Access Compliance Report

Public Rights-of-Way

(Curb Ramps)

Intersection ID: 3879	Main Street: DAVIS_LAKE_PY	Cross Street: DEER_CROSS_TL	Location: NE
ADA ID: 433918E11E35	Ramp Type: PerpDiag	Initial Pass/Fail: Fail	Overall Compliance: No
Severity Score: 42.5			
Codes/Mitigation Info/Possible Solution		Field Measurements/Component Compliance

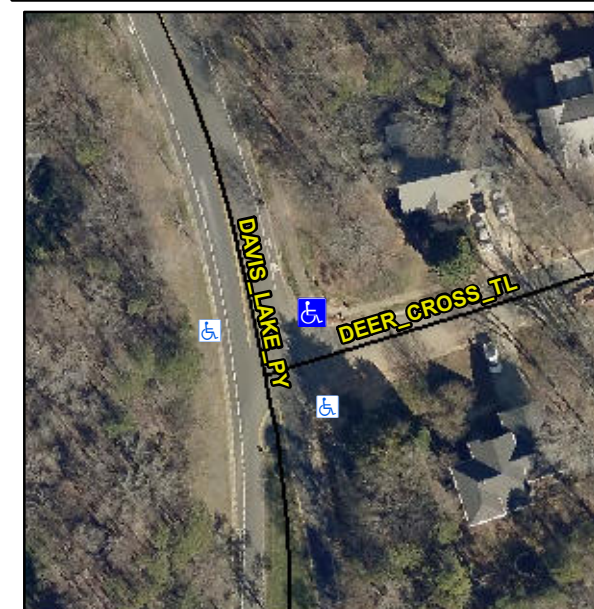
R304.5.1, R304.5.3

Compliance	Description	Data	Compliance	Description	Data
N/A	Ramp Length (in)	93.5	Yes	Ramp Slope (%)	6.7
No	Ramp Width (in)	35.0	No	Ramp XSlope (%)	7.0
N/A	Flare Type LT	N/A	N/A	Flare Type RT	N/A
N/A	Flare Slope LT (%)	N/A	N/A	Flare Slope RT (%)	N/A
N/A	Flare Traversable LT?	N/A	N/A	Flare Traversable RT?	N/A
N/A	Landing Length (in)	N/A	N/A	DWS Provided?	N/A
N/A	Landing Width (in)	N/A	N/A	DWS Contrast?	N/A
N/A	Landing Slope (%)	N/A	N/A	DWS Length (in)	N/A
N/A	Landing X Slope (%)	N/A	N/A	DWS Full Width?	N/A
N/A	Landing Curb? (Y/N)	N/A	N/A	DWS Offset (in)	N/A
N/A	Shared Landing?	N/A			
N/A	Gutter Ponding?	N/A	N/A	Gutter Slope (%)	N/A
N/A	Gutter Lip Ht (in)	N/A	N/A	Gutter X Slope (%)	N/A
N/A	Painted X Walk1?	No	N/A	Painted X Walk2?	No
	X Walk 1 Direction	To W		X Walk 2 Direction	To S
N/A	X Walk 1 Width (in)	N/A	N/A	X Walk 2 Width (in)	N/A
	X Walk 1 Slope (%)	2.8		X Walk 2 Slope (%)	4.2
	X Walk 1 X Slope (%)	4.4		X Walk 2 X Slope (%)	2.0

Remove & Replace Curb Ramp With Two New Directional Ramps or Equivalent.
